## Service Bulletin

Date Issued	08 Dec 2000
Products Covered	<b>VoicePrism</b>
Issue	Fuses on EU units
Description	The specified fuse for 220 to 240V is incorrect. Units shipped for European market have incorrect fuse.  All VoicePrism units shipped from Vtech or in-transit are affected by the specification changed. ONLY EUROPEAN units need to have the fuse changed.

TOP RIGHT HAND CORNER OF MTL0129

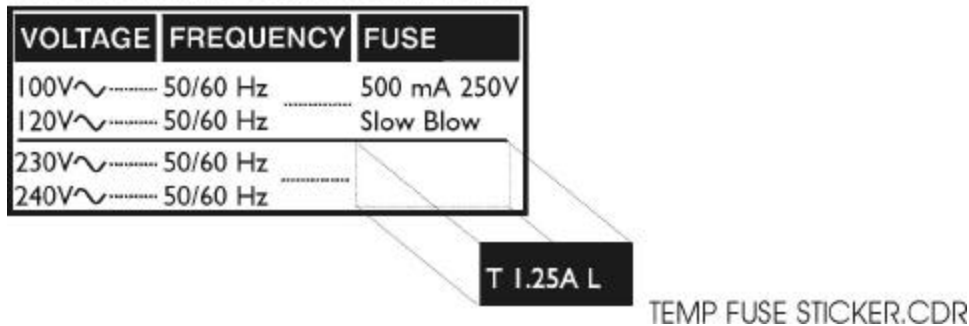
1. Add 'TEMP FUSE STICKER' to rear panel of VoicePrism as per figure 1. Stickers are supplied by IVL Technologies.

2. Print off copy of manual addendum supplied by IVL as a PDF file (Manual Addendum to SUP0065.pdf). Insert the addendum between the front cover and page 1 of the manual.
3. If the unit is being sold to a 220 to 240V market change the fuse to IVL part number FUS0011 (1.25A Time Lag, specifically a Littelfuse 218 1.25A)
